NOV_SCE_IAG_ 20211116-01

NOTICE OF VIOLATION

Report Name: IAG_SCE_20211116-01

On November 16, 2021, I performed a walking inspection of Southern California Edison (SCE) covered conductor installations, 2021 WMP initiative number 7.3.3.3.1, in the city of Simi Valley, California. Detailed findings from this field inspection are laid out in Section II below.

Structure ID: 4194272E

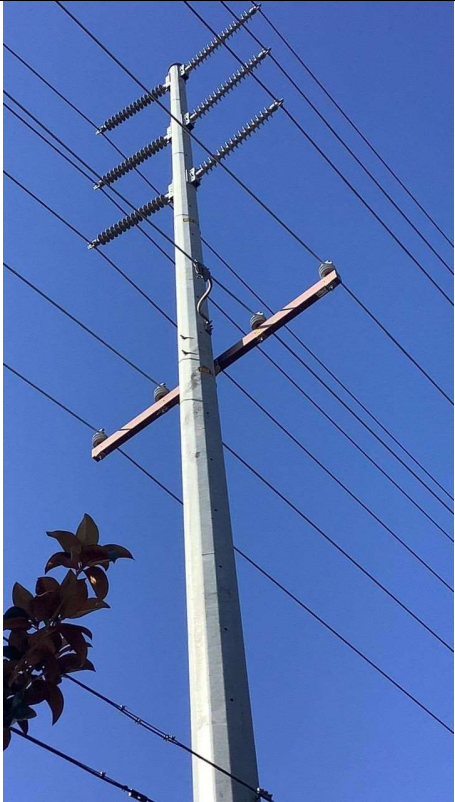
Item1IA1Img1: No vibration dampers are installed

Structure ID: 1922868E

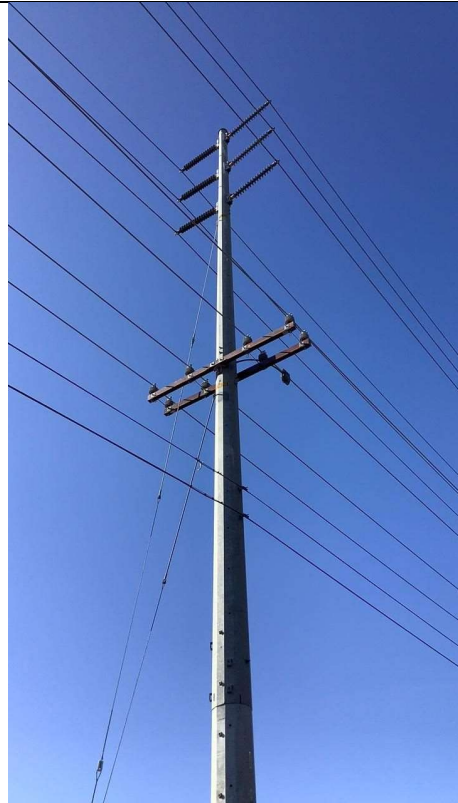
Item3IA1Img1: No vibration dampers are installed

Structure ID: 1922865E

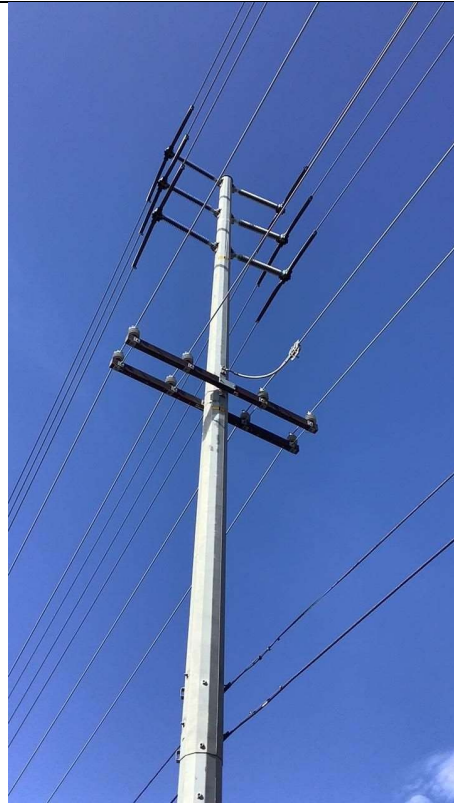
Item4IA1img1: Steel pole observed in the field and no vibration dampers installed

Structure ID: X11396E

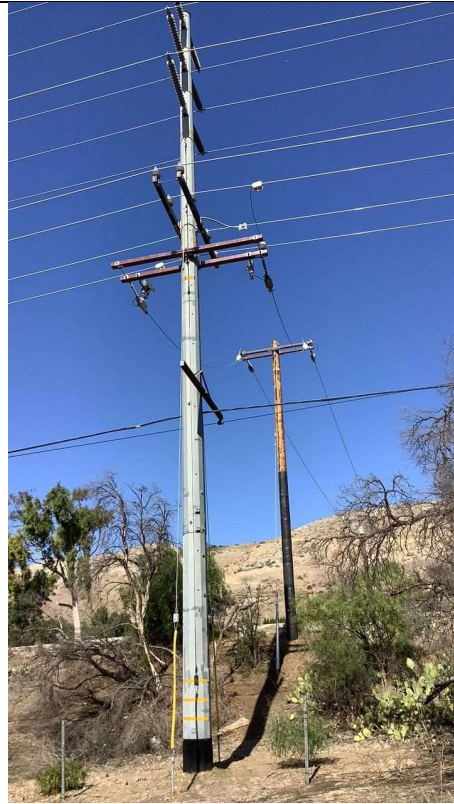
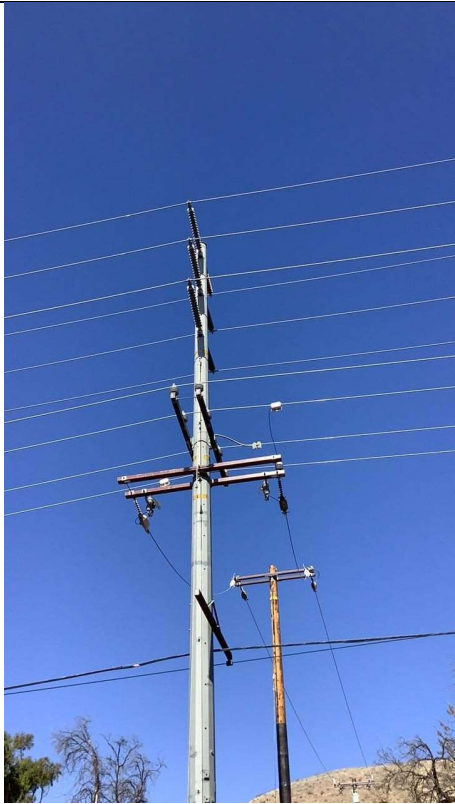
Item5IA1img1: Steel pole observed in the field and no vibration dampers are installed

Structure ID: 4477213E

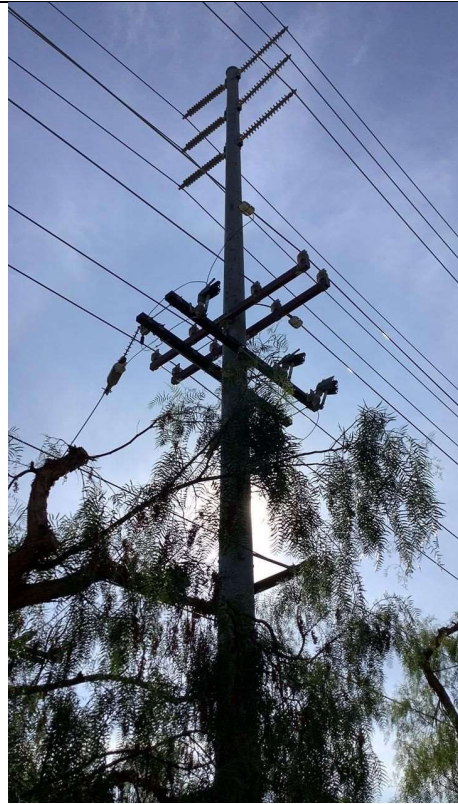
Item9IA1img1: Steel pole observed in the field and no vibration dampers are installed
